STAFF REPORT

APPLICATION FDPA 82-P-069-09-09

APPLICANT: The Shops at Fair Lakes L.P.

RZ PROPOSALS: This FDPA application seeks to amend the ninth approved Final Development Plan (FDP) associated with RZ 82-P-069 (previously approved for mixed use development) to permit a drive-through pharmacy; minor modifications to the existing service station; removal of the existing car wash; addition of a 2,503 square foot quick service food store; and changes to the development conditions associated with the Shops at Fair Lakes. The proposal seeks to increase the existing Floor Area Ratio from 0.36 to 0.39 on the application area; no change to the overall approved 0.27 FAR for Fair Lakes is proposed.

Graphic 1 - Proposed Final Development Plan Amendment

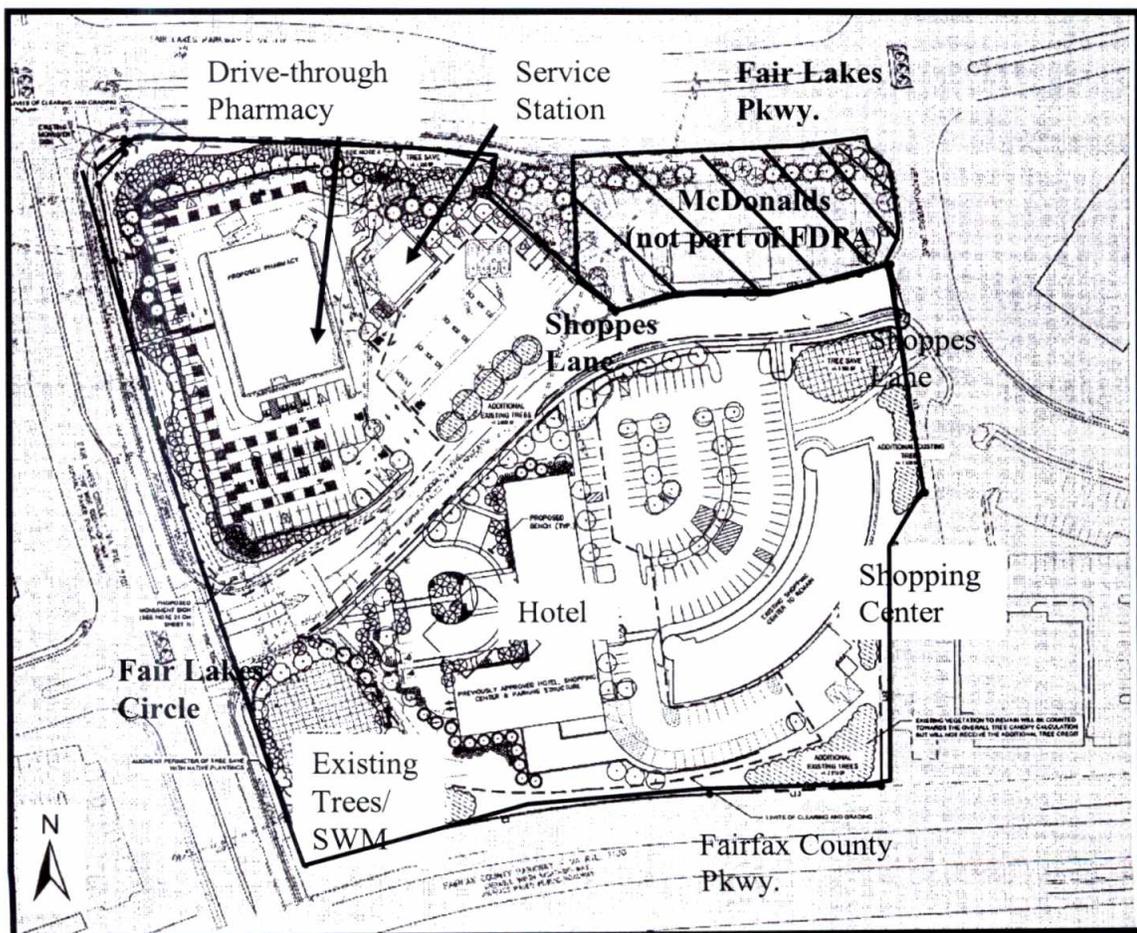
No significant changes south of Shoppes Lane are proposed with the current application. The proposal would increase the FAR from 0.36 to 0.39 for Land Bay VII-B (excluding McDonalds); however, no change to the 0.27 overall FAR for the entire Fair Lakes development (including the additional site specific FAR approved in 2007) is proposed.

Graphic 4: Approved uses on CDPA 82-P-069-03 for Subject Property

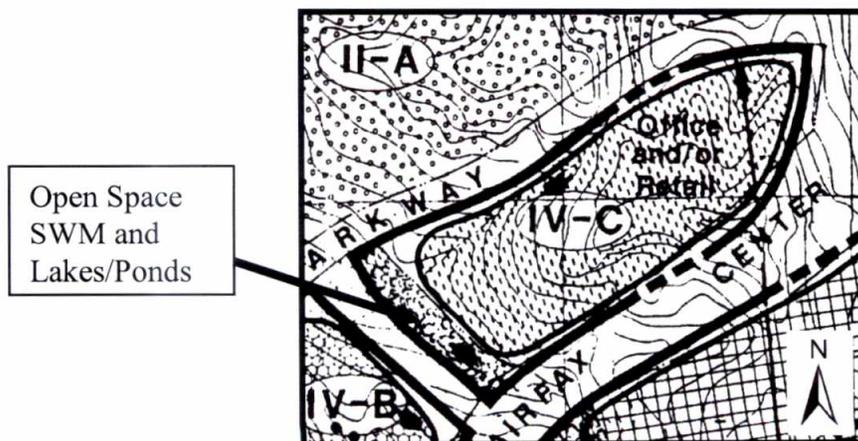
CDPA 82-P-069-3 and CDPA 82-P-069-03-02 currently govern the subject property. CDPA 82-P-069-3 was approved by the Board of Supervisors on July 20, 1987 and permitted office and retail uses on the subject property and depicted the western portion located along Fair Lakes Circle to be used for open space, stormwater management and/or potential lakes or ponds. Graphic 4 shows the approved CDPA.

Graphic 5: Approved uses on CDPA 82-P-069-03-2 for Subject Property

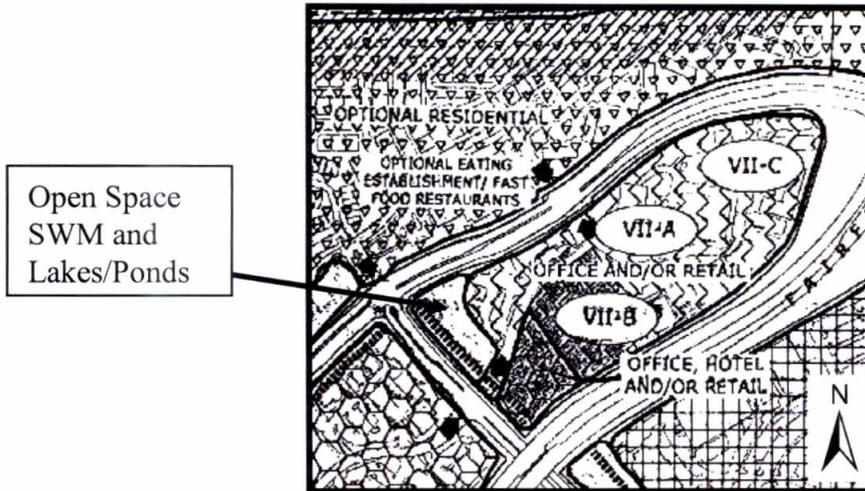
CDPA 82-P-069-03-02 was approved on October 15, 2007 by the Board of Supervisors and amended the southern portion of the subject property to include a hotel with support retail use, while retaining the previously approved open space and stormwater management along the western boundary. Graphic 5 shows the CDPA and associated tree cover.

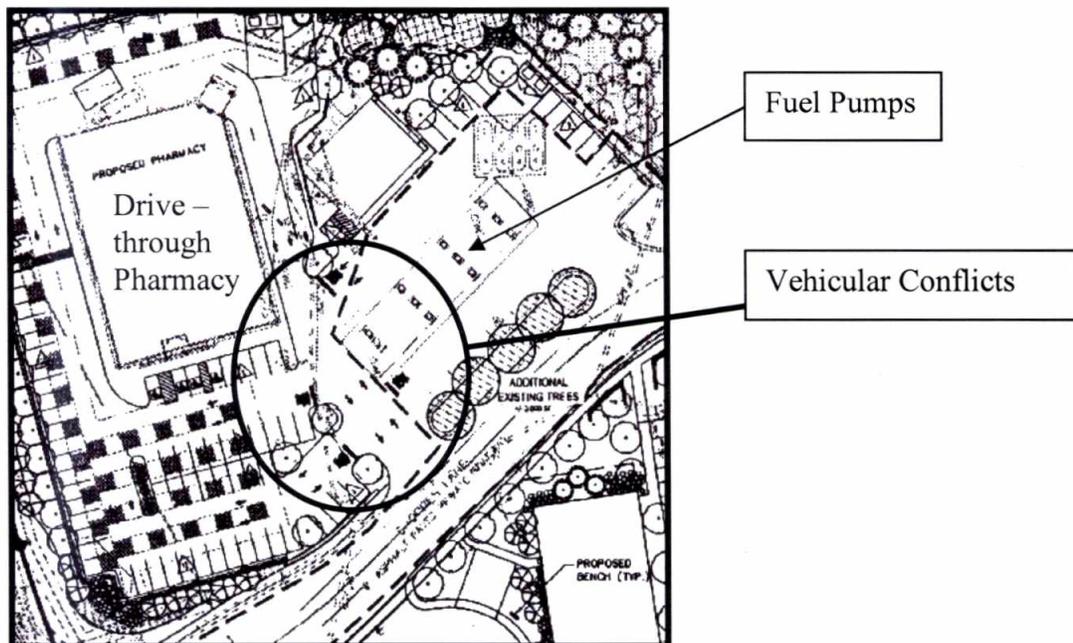
- It is unclear how the proposed landscape plan will be impacted by existing and relocated utilities on the site. Utility constraints could significantly reduce available area for planting significant buffers, other than small plant types and grasses.
- Given the quality of existing trees shown to be preserved on the southwestern portion of the site, the Applicant should be obligated to maintaining their health and condition.

The proposed development does not address the first comment. A majority of the open space area (with existing mature tree cover) located on the northwest portion of the subject property is proposed to be cleared in favor of a drive-through pharmacy with associated parking and new landscaping. In order to achieve any development on this site, an existing above ground stormwater management catch basin in this area would have to be filled and replaced with an underground stormwater management system. The grade on the site would also need to be raised to the street level by approximately 13 feet (based on elevation points shown on the 2009 Topographic Map prepared by the Fairfax County Department of Information Technology). Staff feels that this proposal is in direct conflict with the architectural and landscaping design standards created during the initial rezoning application which have been maintained throughout the 28 year evolution of Fair Lakes. This portion of the site has served as one of the last remaining areas of significant tree preservation along Fair Lakes Parkway, which also provides natural stormwater quality measures and serves as an effective buffer between various uses (residential and non-residential). Staff strongly feels that more emphasis on tree preservation should be provided to protect this area. If this portion of Land Bay VII-B must be developed, the footprint should be minimized and drive-through lanes restricted or eliminated to achieve this objective.

Regarding the second comment, Sheet 3 of the FDPA shows how the proposed new landscaping is located very close to both the existing and relocated utility lines along the property's frontage on Fair Lakes Circle and on a portion of Fair Lakes Parkway. As a minimum measure, Staff has written a development condition to attempt to ensure that the quality and quantity of the proposed landscaping shown on the FDPA will be provided at a minimum, which could result in the further relocation of the utility lines, loss of parking, loss of square footage or a subsequent FDPA application. Additional tree preservation development conditions have been written to attempt to ensure that the reduced area of mature trees will be adequately protected and appropriately maintained. The applicant has also agreed to a development condition, which would create a conservation easement for the tree save area located on the southwest corner of the site.
